UNITED STATES
DEPARTMENT OF THE INTERIOR
BUREAU OF LAND MANAGEMENT

Spitfire 25-1

Section 25 T26S R30E
Eddy County, New Mexico
API No. 30-015-25450

Spitfire 25 1
30-015-25450
RKI Exploration & Production LLC
June 23, 2014
Conditions of Approval

PROPOSED

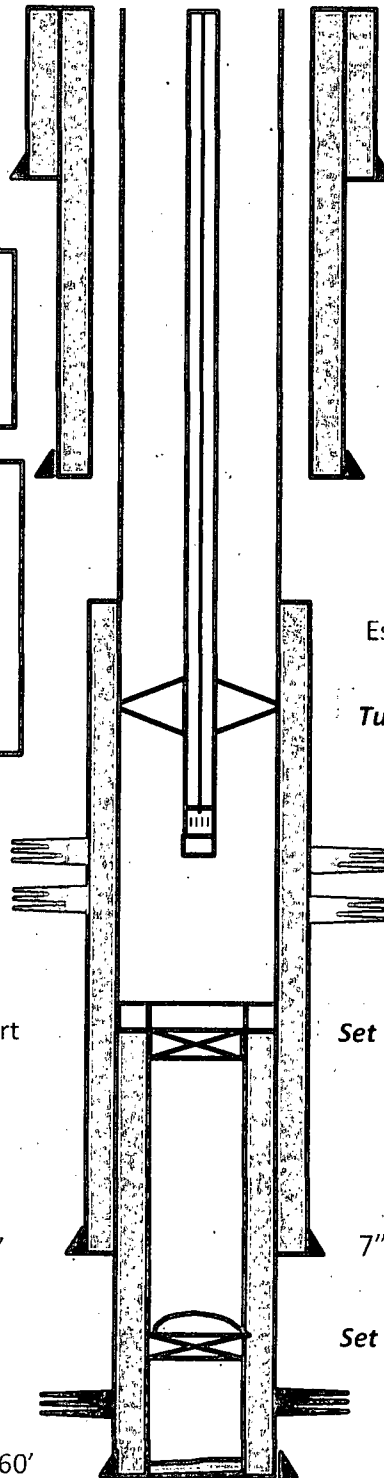
- 1. Operator shall set CIBP at 12,150' with a minimum of 25sx Class H cement on top to cover the shoe. Tag at a minimum of 11,860' required.**
- 2. Operator shall set solid Class H Cement plug from 11,100'-10,890' to seal the top of the Wolfcamp formation.**

- 3. Operator shall set CIBP at 9,075' (a minimum of 50' below stub) with a minimum of 40sx Class H cement on top. Tag required at a minimum of 8,870'.**

- 4. Submit results of the CBL to the BLM. If there is no or little cement behind casing at the interval of the following plug and/or production interval operator may not continue without consulting with the BLM.**

- 5. Operator shall set solid Class H Cement plug from 7,650'-7,474' to seal the top of the Bone Spring formation.**
- 6. Must conduct a casing integrity test before perforating and fracturing. Submit results to BLM. The CIT is to be performed on the production casing to max treating pressure. Notify BLM if test fails.**
